Technical Service Bulletin

SUBJECT:		No: TSB-21-42A-010	
UPDATES TO BODY - SERVICE MANUAL REVISION		DATE: October 2021	
		MODEL: See Below	
CIRCULATE TO:	<input type="checkbox"/> GENERAL MANAGER	<input checked="" type="checkbox"/> PARTS MANAGER	<input checked="" type="checkbox"/> TECHNICIAN
<input checked="" type="checkbox"/> SERVICE ADVISOR	<input checked="" type="checkbox"/> SERVICE MANAGER	<input checked="" type="checkbox"/> WARRANTY PROCESSOR	<input type="checkbox"/> SALES MANAGER

This TSB provides updated content for the Body section of the affected Service Manual, Loose Panel Removal and Installation.

- 2020 Eclipse Cross Service Manual, Group 42A-Body -> Loose Panel

LOOSE PANEL

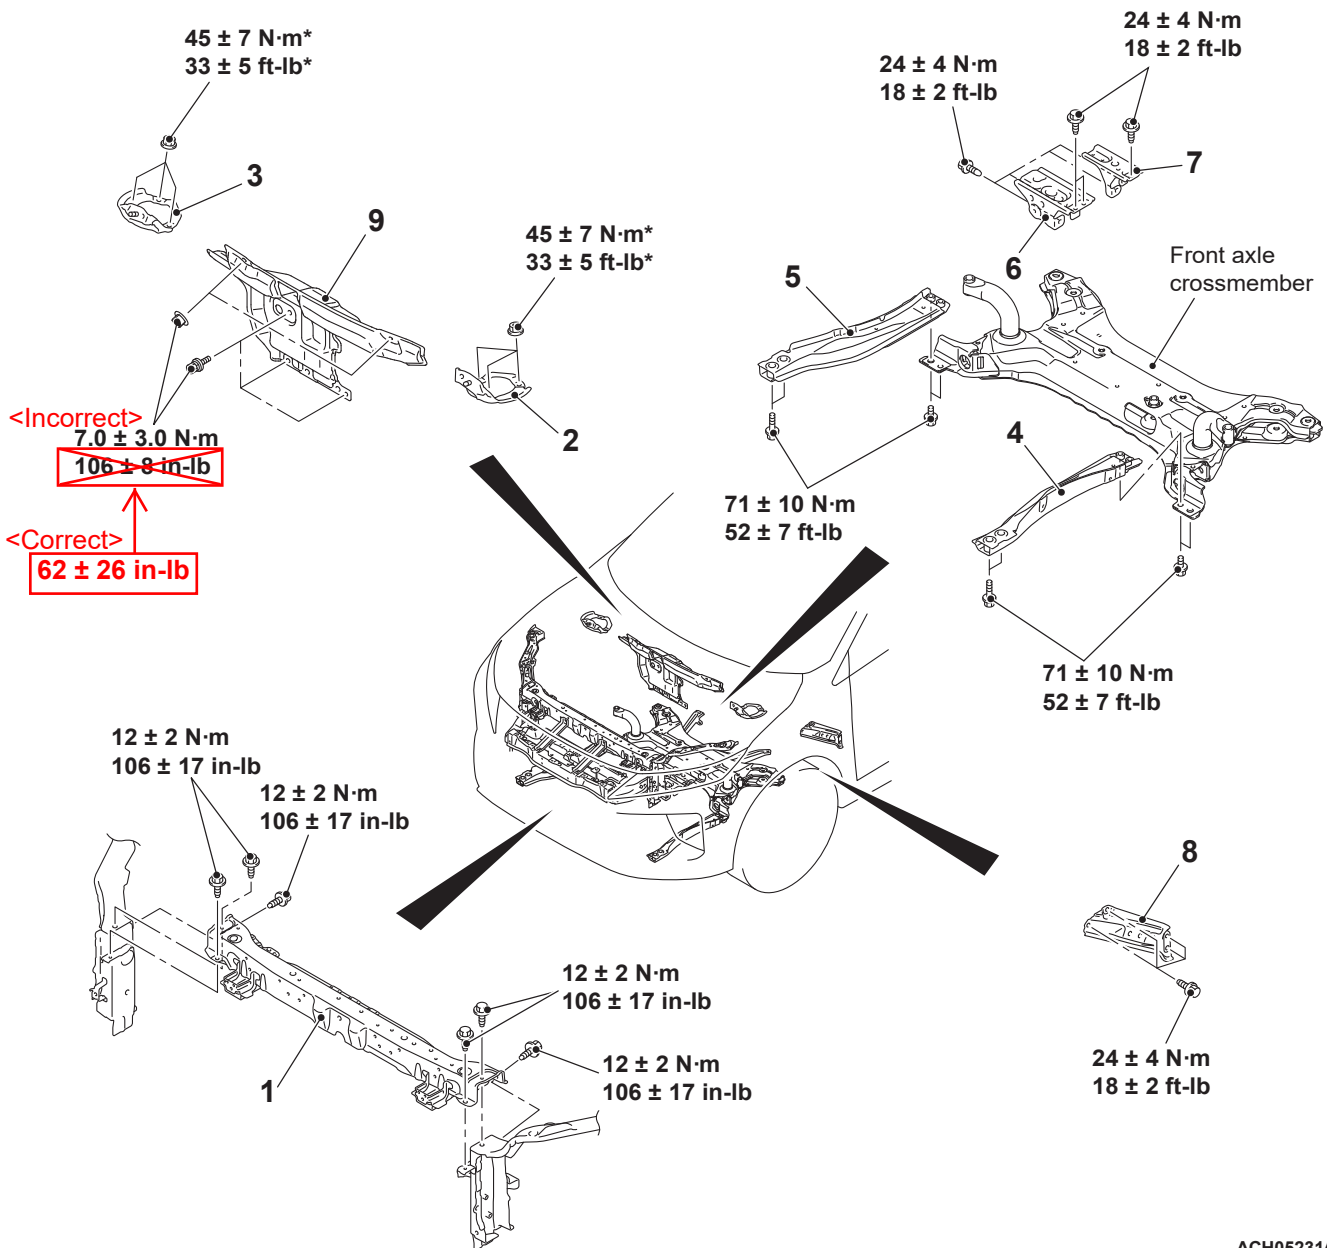
Please replace the page in the applicable Eclipse Cross Service Manual, Group 42A-Body -> Door section as follows:

- 2020 Eclipse Cross Service Manual, Group 42A-Body -> Loose Panel Removal and Installation - Attached sheet 9

- Disconnect the battery (-) terminal and wait for 60 seconds or more before starting work. Insulate the disconnected (-) terminal by wrapping a tape.
- Handle the front impact sensor with sufficient caution, and do not drop the sensor or allow contact with water, oil, or others. If a dent, crack, deformation and others are discovered, replace it with a new one.
- The parts indicated by * indicates parts which should be temporarily tightened, and then fully tightened with the vehicle standing on the ground at curb weight.
